Squeak Noise From Rear Suspension

Service Category Suspension

Section Rear Suspension

YEAR(S)	MODEL(S)	ADDITIONAL INFORMATION
2016 - 2019	RX350, RX450H

Figure 1.

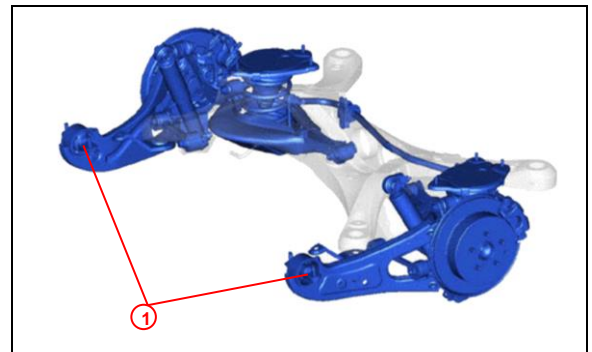
1. Confirm the condition exists.
Using ChassisEAR™ (or equivalent), test-drive the vehicle over an uneven road surface, such as a sloped driveway, to verify the condition is coming from the rear trailing arm bushings.

Applying soapy water to the suspected bushing may temporarily diminish the noise intensity and help identify the source of the noise.

Figure 2. LH Side

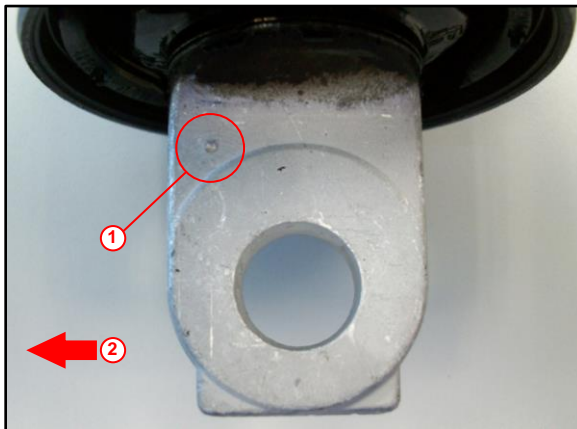
- BEFORE installing NEW parts, confirm the identification mark as shown. If this mark is NOT present, the part is incorrect and should NOT be installed.

The identification mark on the NEW part faces the outside of the vehicle.

- Replace BOTH rear trailing arm assemblies even if only one side is emitting the squeak noise.
